Amendments to the Drawings:

REMARKS/ARGUMENTS

FIG. 18

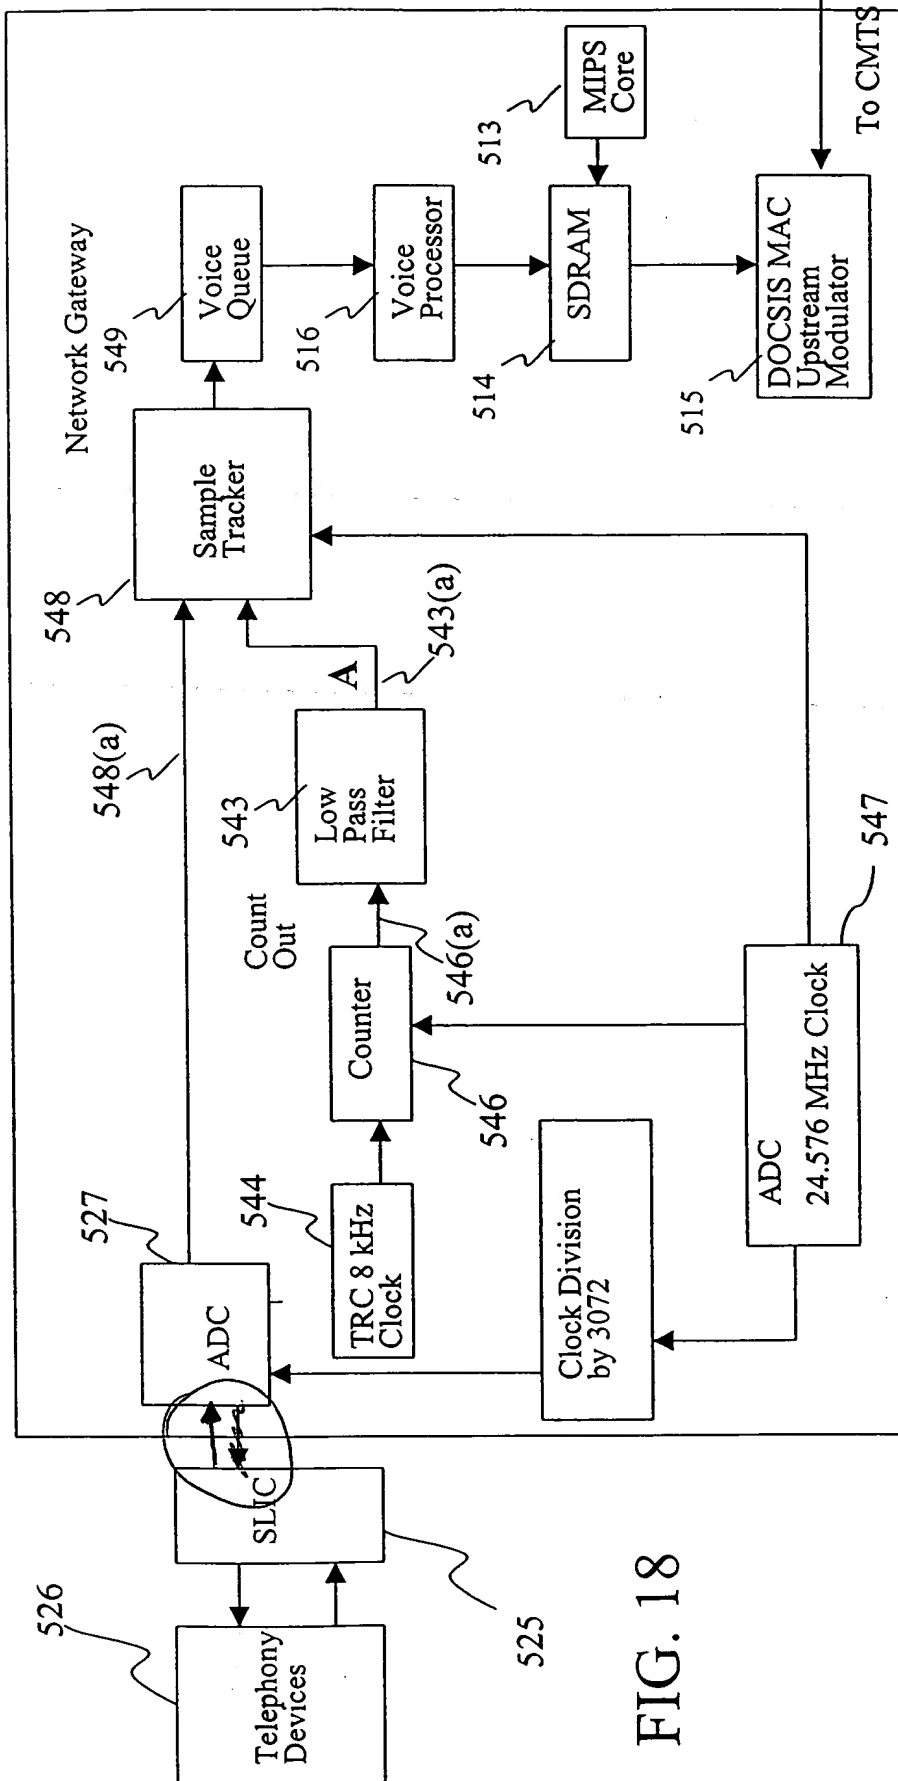
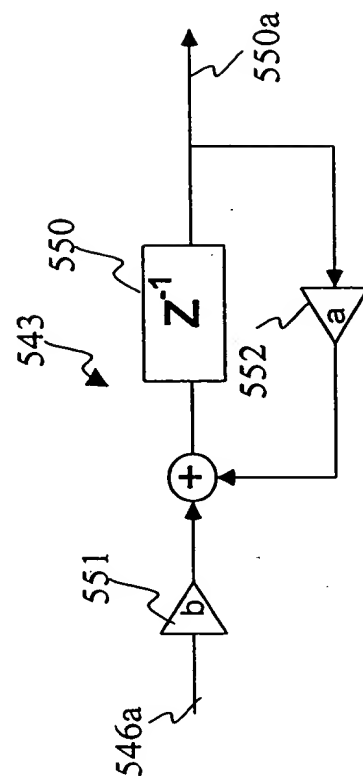
The attached sheet of drawings includes changes to Fig. 18. This sheet, which includes Figs. 18 and 18a, replaces the original sheet including Fig. 18 and 18a.

FIG. 18 is objected to. FIG. 18 is amended, as suggested by the Examiner. Therefore, it is respectfully requested that the above objection be withdrawn.
